Environmental Protection Act 1986

**NOTICE OF DECISION TO APPROVE AMENDMENTS TO PROPOSAL DURING
ASSESSMENT**

Greater Paraburdoo Iron Ore Hub Proposal
Assessment No. 2189

Figure 1. Greater Paraburdoo Iron Ore Hub Proposal Development Envelope and Mining Exclusion Zones and Mining Restriction Zones

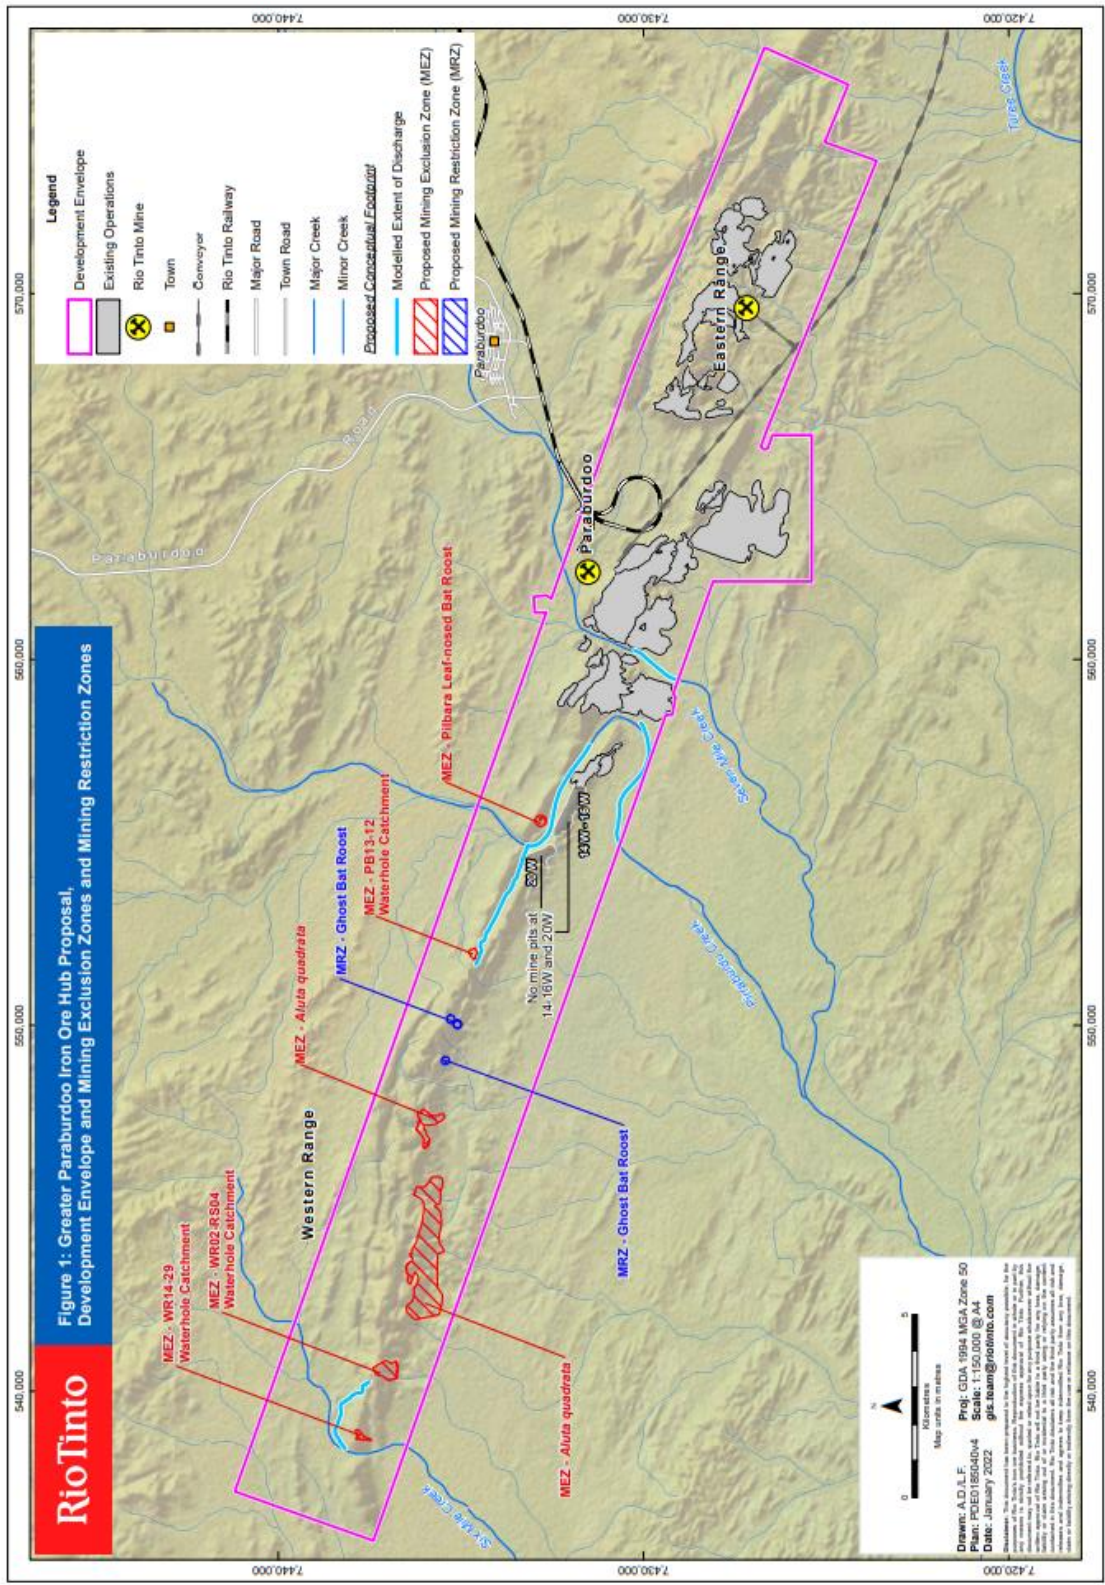
- Amending the conceptual footprint to minimise impacts to cultural heritage and *Aluta quadrata* (Threatened-endangered under the *Biodiversity Conservation Act 2016*).
- Removal of mine pits at 14W-16W and 20W (restriction not applicable to infrastructure).
- Application of mining exclusion zones and mining restriction zones to protect terrestrial fauna values, three gorge pools at Western Range and *Aluta quadrata*.

See the attached amended Proposal Content Document and Figure 1.

Proposal element	Location/description	Maximum extent, capacity or range
Physical elements		
Mine and associated infrastructure	Figure 1	<p>Clearing of up to 4,300 ha within a 17,422 ha development envelope*.</p> <p>No direct disturbance permitted within Mining Exclusion Zones.</p> <p>No pit crests to intersect Mining Restriction Zones. Disturbance restricted to potential material spillage and rilling associated with drill and blast activities only.</p> <p>No mine pits at 14W-16W and 20W (restriction not applicable to infrastructure).</p>
Operational element		
Dewatering and water supply	-	Abstraction up to 14 GL/a.
Management of surplus water	Figure 1	<p>Managed via options including:</p> <ul style="list-style-type: none"> • discharge to disused mine pits (storage and passive recharge) • storage infrastructure • provision to other water users • controlled discharge of up to 1.7 GL/a of surplus water** to watercourses (Seven Mile Creek, Pirraburdu Creek, Six Mile Creek), not extending beyond the development envelope under natural no-flow conditions.

Figure 1. Greater Paraburadoo Iron Ore Hub Proposal Development Envelope and Mining Exclusion Zones and Mining Restriction Zones

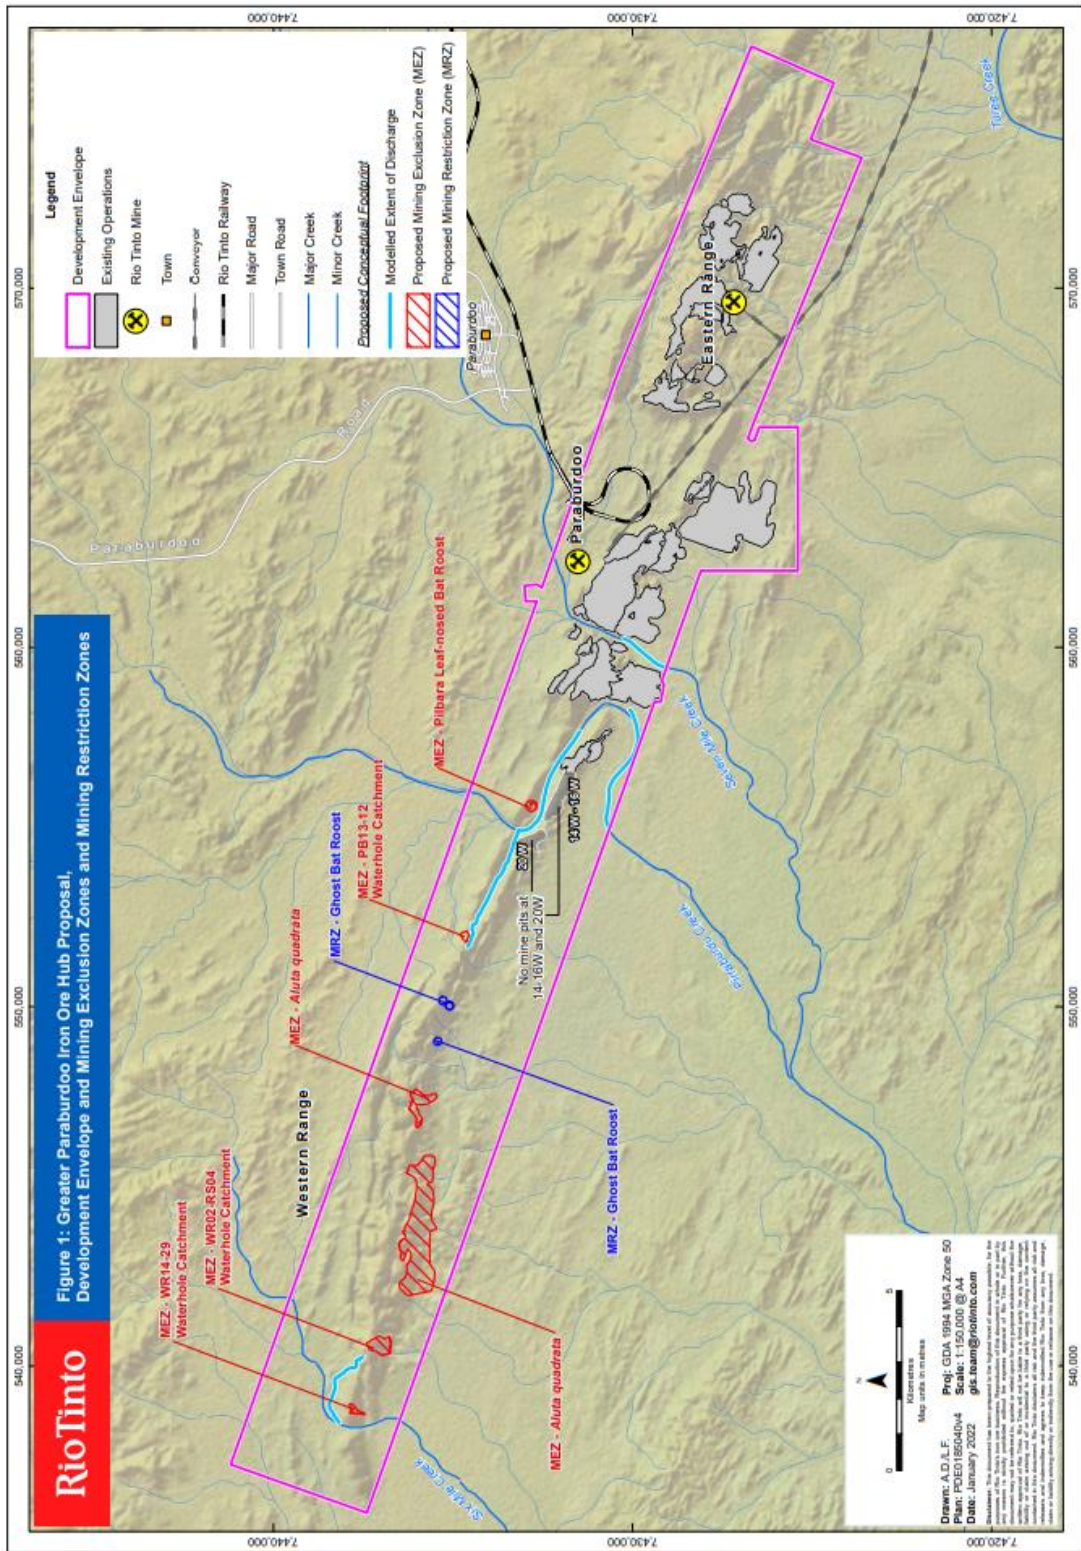
- amending the conceptual footprint to minimise impacts to cultural heritage and *Aluta quadrata* (Threatened-endangered under the *Biodiversity Conservation Act 2016*)
- removal of mine pits at 14W-16W and 20W (restriction not applicable to infrastructure)
- application of mining exclusion zones and mining restriction zones to protect terrestrial fauna values, three gorge pools at Western Range and *Aluta quadrata*.

The proponent has modified waste dump (WD3) to create a nominal 200-metre-wide vegetation corridor between WD3 and the 50W pit. The purpose is to maintain habitat connectivity and enable pollinator access and maintain genetic connectivity between the two expressions of the Western Range population.

The proponent has also modified the pit crest of 36-50W and 55-66W in several areas above *Aluta quadrata* to minimise the generation of rilling material when creating the pit crest. This subsequently reduces the pit disturbance footprint enabling the capture of 96.1% of the Western Range population within mining exclusion zones.

Proposal element	Location/description	Maximum extent, capacity or range
Physical elements		
Mine and associated infrastructure	Figure 1	<p>Clearing of up to 4,300 ha within a 17,422 ha development envelope*.</p> <p>No direct disturbance permitted within Mining Exclusion Zones.</p> <p>No pit crests to intersect Mining Restriction Zones. Disturbance restricted to potential material spillage and rilling associated with drill and blast activities only.</p> <p>No mine pits at 14W-16W and 20W (restriction not applicable to infrastructure).</p>
Operational element		
Dewatering and water supply	-	Abstraction up to 14 GL/a.
Management of surplus water	Figure 1	<p>Managed via options including:</p> <ul style="list-style-type: none"> • discharge to disused mine pits (storage and passive recharge) • storage infrastructure • provision to other water users • controlled discharge of up to 1.7 GL/a surplus water** to watercourses (Seven Mile Creek, Pirraburdu Creek, Six Mile Creek), not extending beyond the development envelope under natural no-flow conditions.
